UNITED STATES PATENT AND TRADEMARK OFFICE

10/520,798

Office Action Summary	Application No. 10/520,798	Applicant(s) SUN ET AL.	
	Examiner DAVID W. SCHEUERMANN	Art Unit 2834

DETAILED ACTION

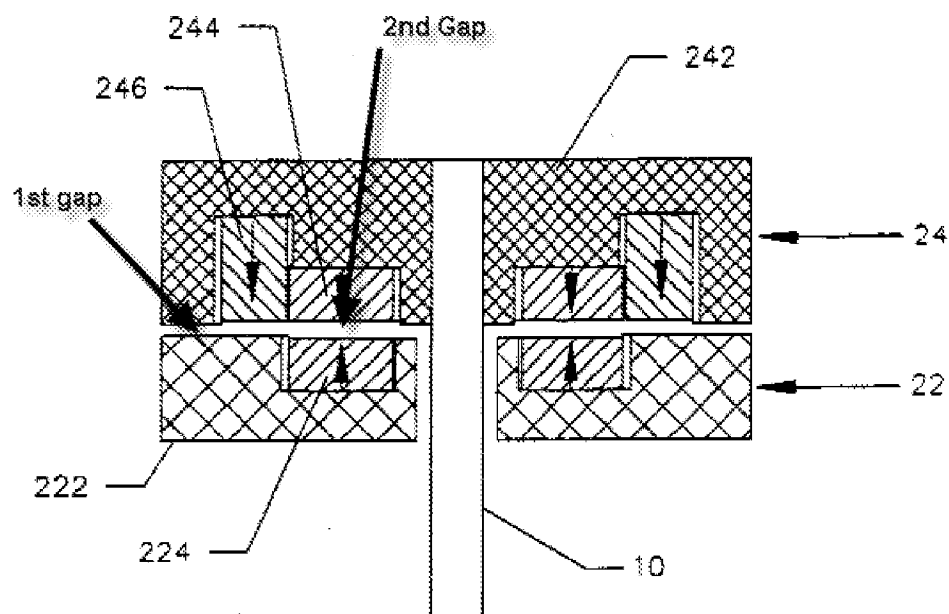
Claims 1-3, 12, 16-18, 20-22 and 30 are rejected under 35 U.S.C. 102(b) as being anticipated by Imlach, US 5894181. Imlach, US 5894181 shows:

A thrust load enhancement device for a rotor-bearing system, comprising
a stator 22 mounted on a rotation axis of the rotor-bearing system;
a rotor 24 separated from said stator by a first magnetic air gap on the
rotation axis; and

at least one permanent magnet separated from one of: i) said stator and
ii) said rotor by a second magnetic air gap; (see figure 2a labeled below)

wherein said at least one permanent magnet, said stator and said rotor
form a magnetic circuit characterized by a flux path, a flux in said first and

second air gaps generating a compensation force between said rotor and said stator that opposes an external force F_{ext} . (inherent since the gaps remain substantially constant)

Re claims 3 and 22, note that the permanent magnet 224, supra, is separated by 2nd gap.
